Whale Tail 2025 Annual Open Pit Geomechanical Inspection Report

March 10, 2026

RE: Meadowbank Complex - Amaruq Site - 2025 Annual Open Pit Geomechanical Inspection

Observations - Northwest Wall Failures on HSB #4/#1 (Cont'd)

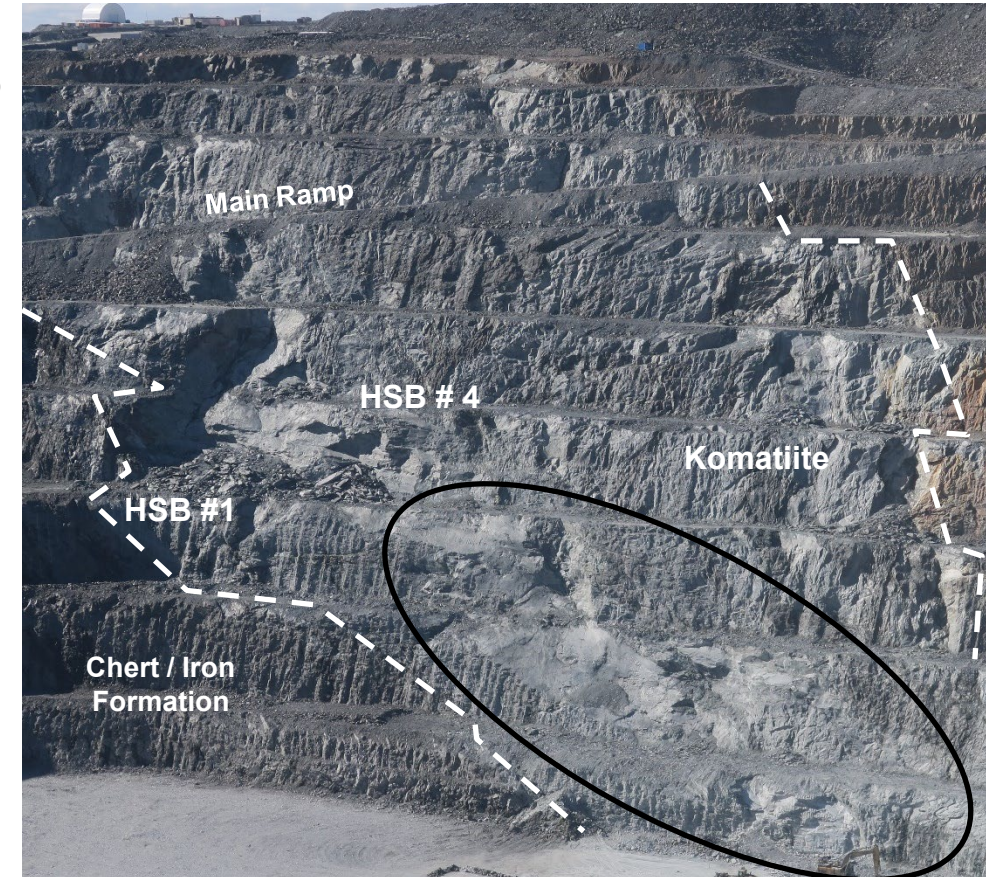
- A second series of five failures occurred on the lower Northwest Wall between HSB #4 and #1 (circled in black), often initiating on HSB 4. One failure occurred in February 2025 and the remainder occurred in June and July, 2025. The individual failures ranged in size from 225 to 10,500 tonnes, with a cumulative tonnage to date of 15,700 tonnes.

- All of the failures occurred when a berm was in place as required by the Working with Komatiite procedure, and all of the failed material was retained by the berms. The 225 tonne failure on July 4, 2025 occurred when an adjacent area was being scaled and the berm had been partially removed to allow access. However, the berm was in place directly below the failure.

- These failures are planar failures along the basal plane of the wedge that formed in the upper Northwest Wall. The basal plane structure appears to be constrained by HSB #1 and #4 and thus may be associated with a shear zone. One possibility is that these are associated with the southeast dipping reverse shears identified by David Rhys of Panterra Geoservices in 2023. The lithology models suggests that north-south trending sub-vertical dykes may have acted as release planes but it was difficult to find evidence of this in the field.

- These failures are expected to continue to occur as HSB #4 and #1 are exposed in new benches. Comments on managing these failures are provided on a subsequent slide.

Observations - Northwest Wall Failures on HSB #2

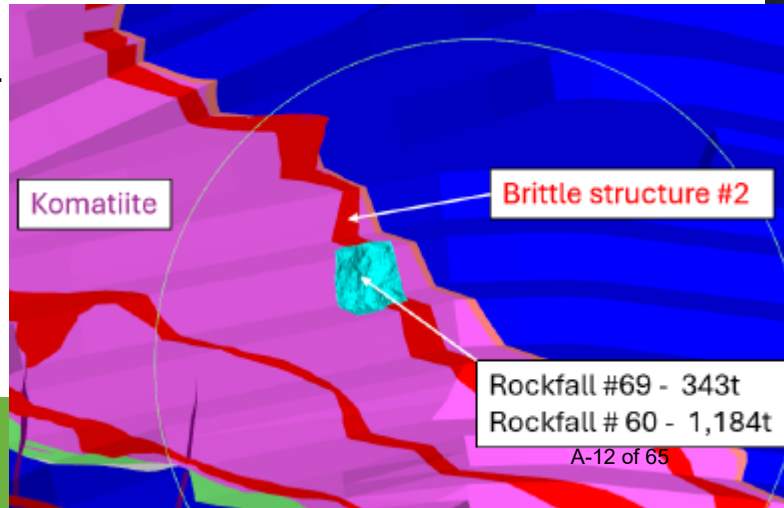
- Two bench scale wedge failures occurred along HSB #2 since the last annual inspection (circled in black at right). An initial wedge failure of 1,200 tonnes occurred in September 2024. A second failure of 350 tonnes occurred in the same location in June 2025 during freshet.

- HSB #2 is close to, and sometimes coincident with, the northern contact between the Komatiite and the Greywacke.
- HSB#2 formed the northern side of the failure plane while the western failure plane appears to have been through the rock mass.

- Similar failures are expected to continue to occur along HSB#2. This area should continue to be a focus of scaling when establishing new benches.
- In some cases, trim blasting could be used to proactively remove the potential wedge.

Observations - Northwest Discussion

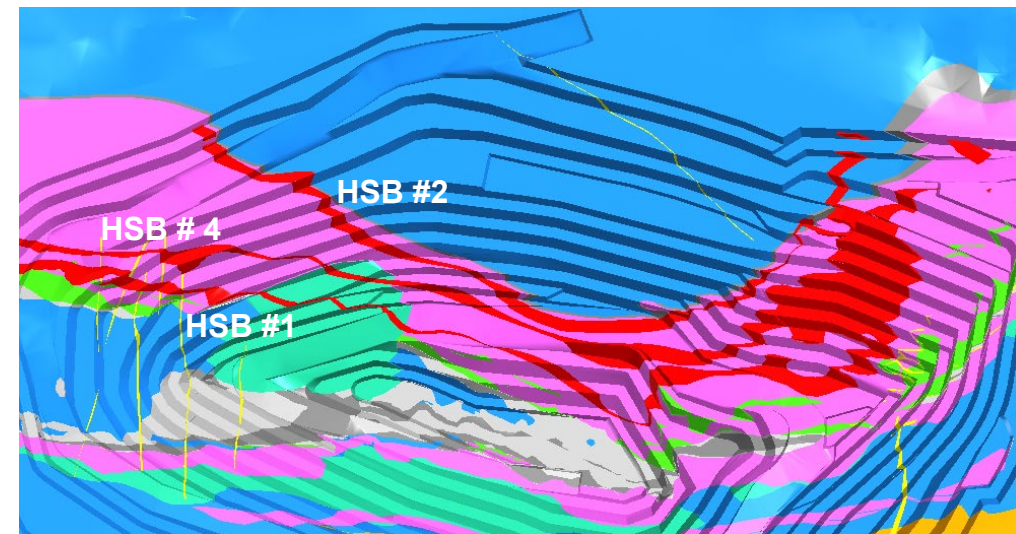
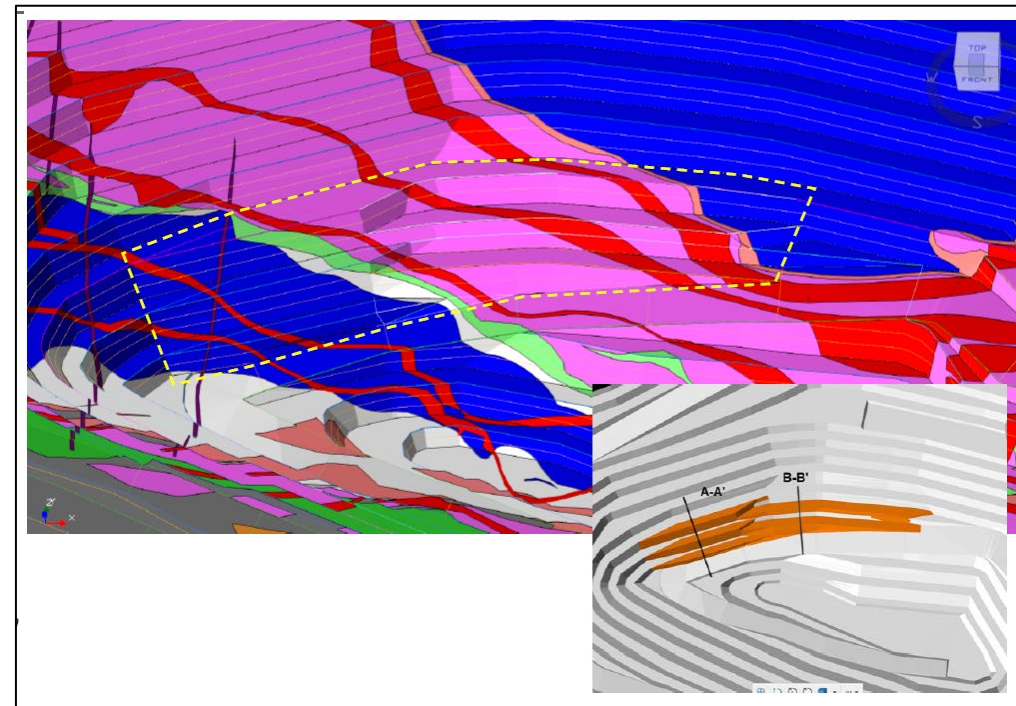
- While the Komatiite itself has performed well in the Northwest Wall, failures are expected to continue to occur along HSB #1, #4, and (to a lesser extent) #2.

- The loss of the catch benches increases the rockfall hazard for mining activities below this area. While this is currently being managed with berms, AEM has adjusted the mine plan to create a small step-in above the ramp in the area outlined in yellow in the image at upper right. This is reasonable but it required locally steepening the bench face angle of the benches in the Greywacke between the step-in and the ramp. There is an increased potential for bench-scale failures as a result and the area should be carefully monitored. Note that design changes of this magnitude should be reviewed by the Design Engineer (KP).

- The Brittle / High-Strain Structures should be mapped and the results used to validate/refine the structural model.
- The location and impact of potential future failures along the HSBs should be reviewed (particularly where they are located along the ramp) and a mitigation plan developed. This could include local adjustments to the bench geometry / trim blasting to mine out potential wedges, shear pins, buttresses, etc.

Observations - Northwest Wall - Wedge

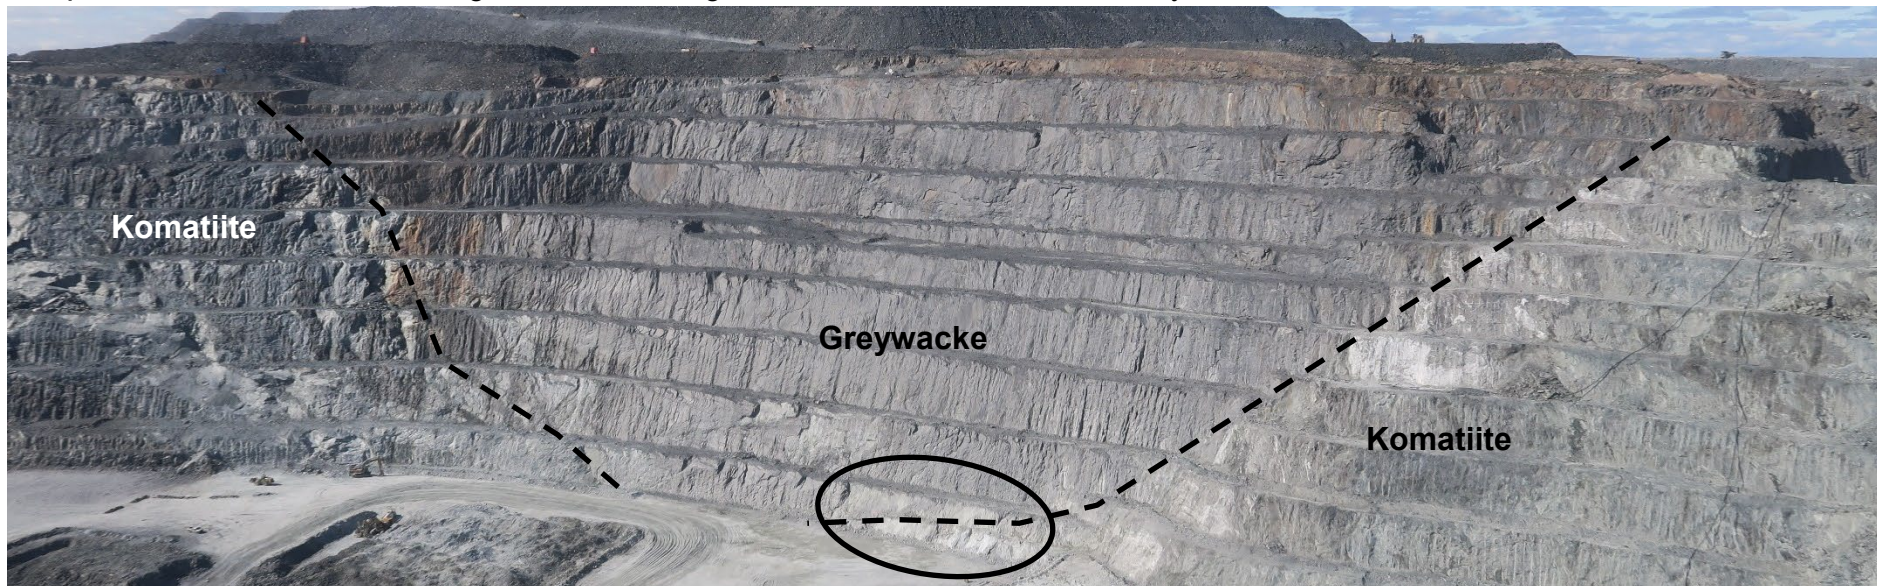
- The wedge was identified above the ramp in 2020.
- Ravelling of material over time has resulted in the wedge becoming more prominent. It is believed that most of the ravelling occurred when the Phase 2 Ramp was established below this area between December 2022 and January 2023.
- There is a partial bench between the wedge and the Phase 2 ramp. However, it is likely that material would reach the ramp if the wedge failed.
- The wedge is a focus of the regular visual inspections and the drone surveys.
- No significant changes in the condition of the wedge were observed between the 2023 and 2025 annual inspections.
- Continue to monitor this area closely, both from the ramp and the overlook above. If further deterioration is observed, further mitigation will be required (e.g., knocking down the wedge).

Observations - Northeast Wall

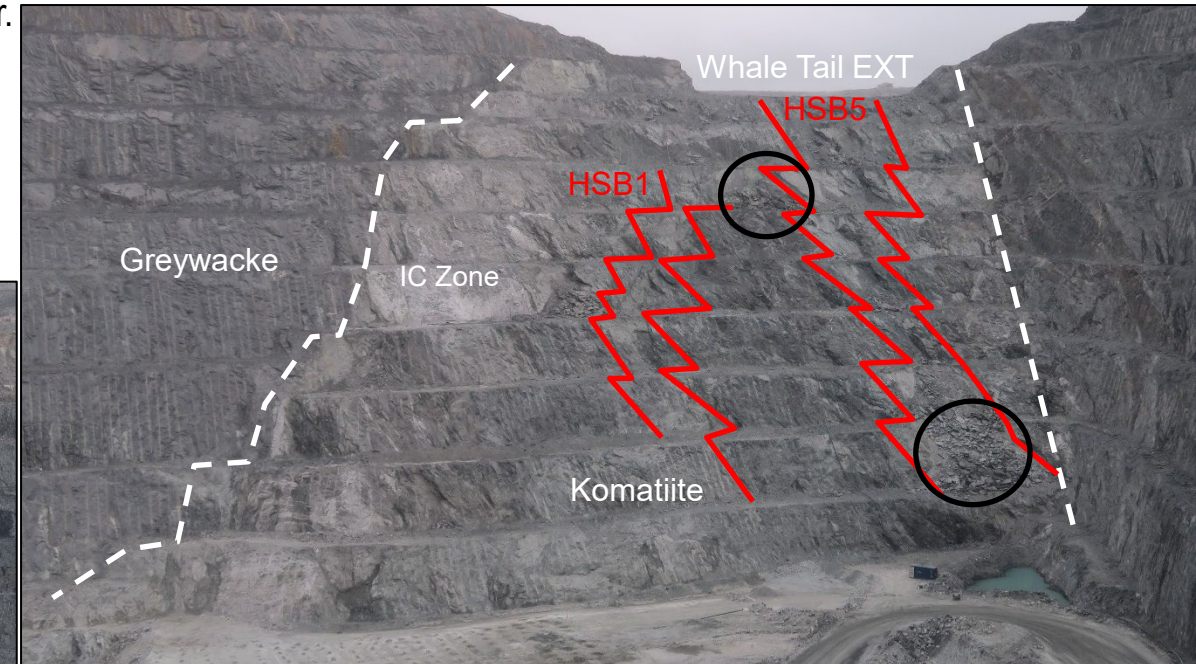
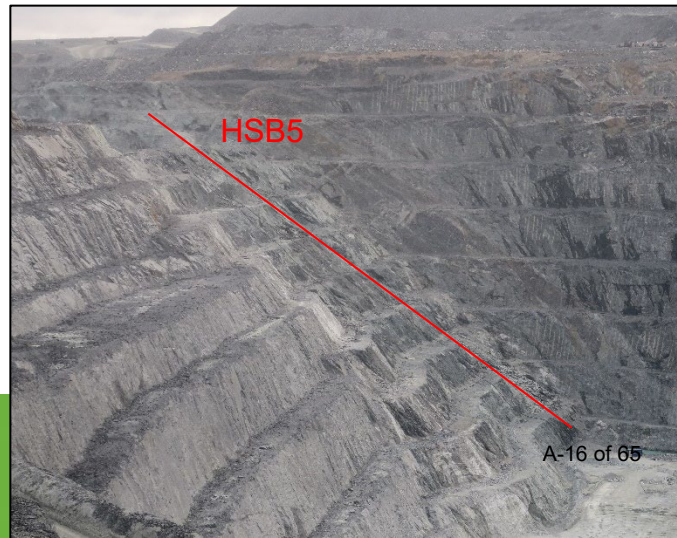
- Final wall in Design Sector D4K.
- This sector is within the Komatiite and has been characterized by a series of bench scale failures associated with the weak rock mass and the High-Strain / Brittle Structures (select structures are shown in red below). The slope design was revised in December 2021 and has been successful in managing the performance of the slope.

- Two rockfalls have occurred in this sector since the last annual inspection, ranging in size from 500 to 900 tonnes (circled below). Both of the failures occurred in the fall, above the active bench and in an area where berms were in place due to the Working with Komatiite Procedure. The failure mechanism is a hybrid wedge failure along the foliation, consistent with previous failures in this sector.

- High Strain / Brittle Structure #5 has had the greatest impact on slope performance to date. The benches within the IC Zone along the west contact have performed better than the other benches in the Komatiite.

- It is expected that rockfalls and bench-scale failures will continue to occur. The wall continues to be a focus for the Rock Mechanics team. The Working with Komatiite Procedure is a key tool for managing the geotechnical risk in this sector.

Observations - Northeast Wall (Cont'd.)

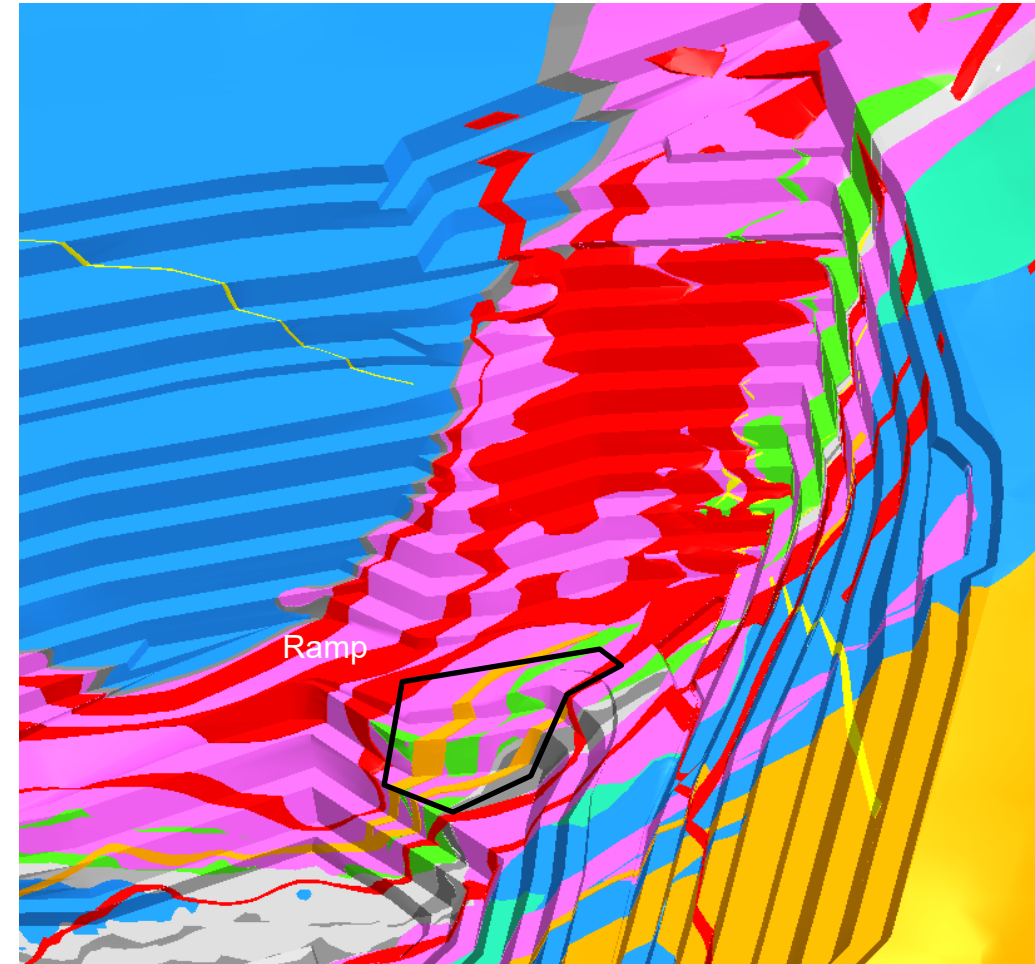
- Two benches (one 7 m and one 21 m high) below the ramp in the Northeast Wall of the Whale Tail open pit are intended to be established during the winter to take advantage of the strengthening effect of the frozen rockmass within the permafrost. The benches are outlined in black at right and are intended to be buttressed before the rock mass thaws. If the rock mass thaws before the benches are buttressed, bench-scale and multi-bench scale failures are expected to occur.

- The first 7 m bench is planned to be established in October 2025 and the second bench is planned to be completed by March 2026. The buttress has not yet been designed in detail and has not been incorporated into the LOM or budget mine plans. A high-level review suggests that it could be constructed by the end of April, but this needs to be confirmed.

- The buttress should be designed in detail and included in the LOM and Budget mine plans. Ensure that the benches will remain frozen between development and buttressing prior to freshet. If this is not possible, a revised mining strategy will be required for this area.

- It is important that the orientation of the foliation and HSB Structures be confirmed through mapping as these benches are established.

Observations - Northeast Wall (Cont'd)

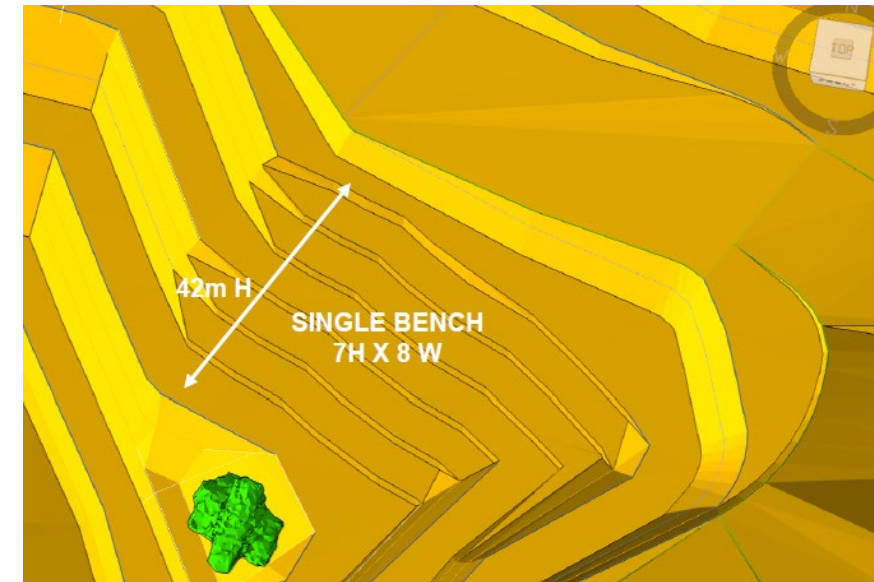
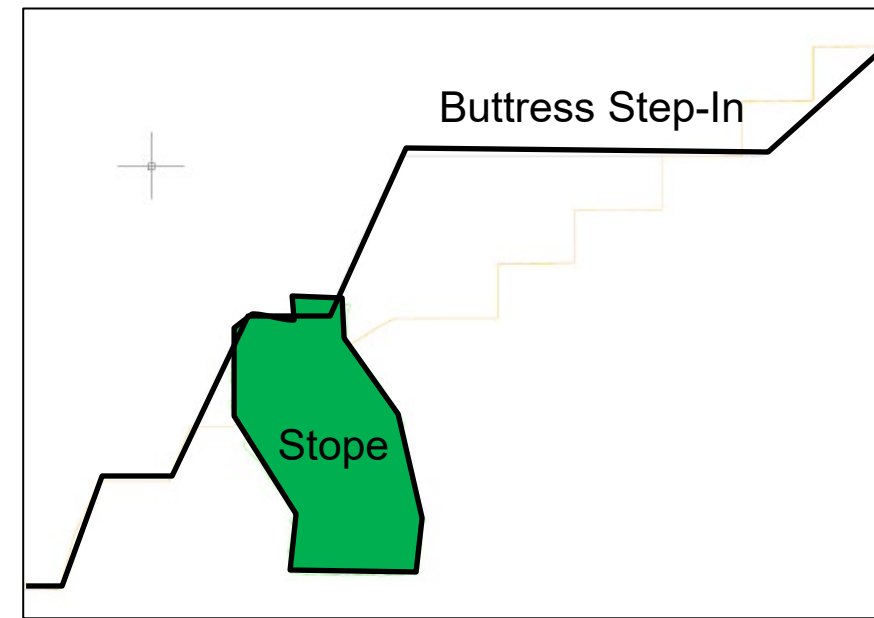
- The 260-ST-206 is located below the step-in on which the buttress will be constructed. The stope was planned to be backfilled with Cemented Rockfill (CRF) but began to cave during backfill placement and had to be backfilled with Unconsolidated Rockfill (URF) to stabilize the stope. The majority of the stope is backfilled with URF and caved material.

- URF will be exposed in the open pit wall and will be a potential rockfall hazard. In addition, migration of the URF could result in a loss of confinement acting on the benches intersected by the stope, increasing the potential for a bench-scale instability (which could impact the buttress above). However, a portion of the bench is expected to be established in the Chert and Iron Formation, which are the most competent units at the deposit.

- The mine has been evaluating different options for managing the URF. The focus to date has been on modifying the slope above the stope to use single benching and eliminate the step-out in order to allow the URF to be graded to the angle of repose once it is exposed (see image at lower right). This results in an inter-ramp angle that is steeper than what the analyses suggest is achievable.

- Recommend reviewing more tactical measures for managing the stope including:
 - Modifying the local bench geometry to remove or reduce the size of brows formed by the exposure of the stope in the wall.

- Applying shotcrete to the URF, draping chain-link mesh over the area, and/or constructing rockfall berms to manage the rock fall hazard.
 - Installing ground support (e.g., cable bolts) to reinforce the brow above the stope.

Observations - East Wall

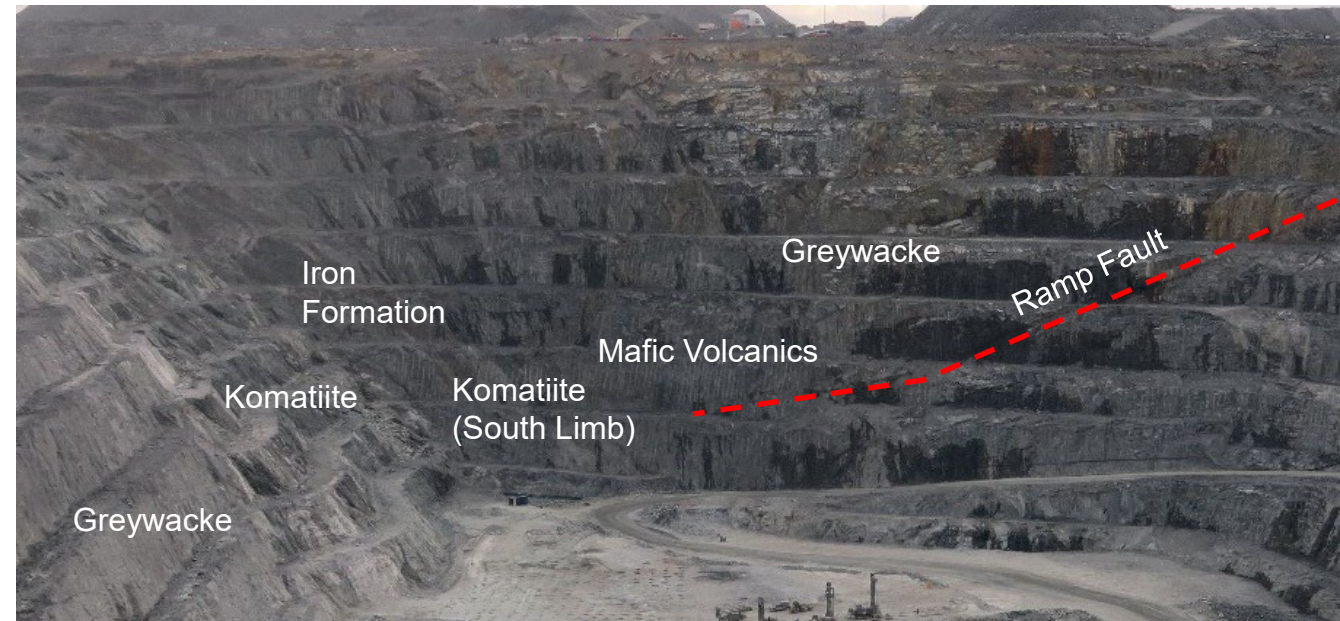
- Final wall in Design Sector E4, transitioning into G5.
- Note that the southern portion of this wall, in Design Sectors F6 and G5, is discussed on the next slide.

- The benches have generally performed well. Increased crest loss occurred on the upper benches where adverse structure (Joint Set B or C) is present. The foliation strikes roughly perpendicular to the wall, which is favourable for bench stability.

- The rock mass is generally competent, though localized shear zones attributed to the Brittle / High Strain Structures and the Ramp Fault are observed within it. These structures represent a potential rockfall hazard, but this has not been an issue to date.

- Minor seepage is consistently occurring along the benches from the crest of the open pit to the base. The source of this is uncertain. One possibility is AP5 which is located east of the open pit along strike of the lithologies and HSBs exposed in the southern portion of the wall.

Observations - Southeast Wall

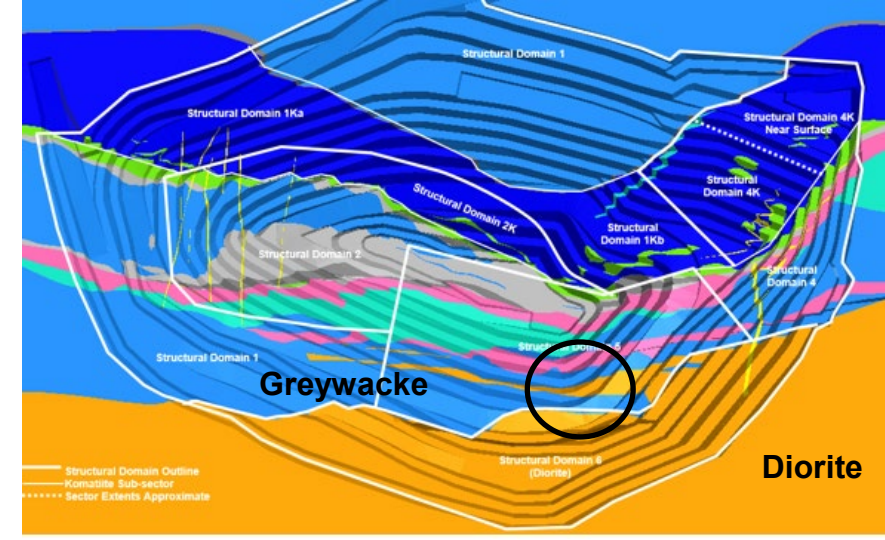
- Final wall in Design Sector F6, transitioning to G5.
- The slope geometry recommendations for this sector were adjusted in early 2023 by AEM to reduce the catch bench width from 16 m to 13 m based on the observed slope performance.

- Subsequently, the 5046 bench experienced > 6 m of crest loss over significant intervals of the catch bench. An additional catch bench was added above the ramp as a rockfall protection measure and a rockfall fence was installed in November 2024 (circled in black at right).
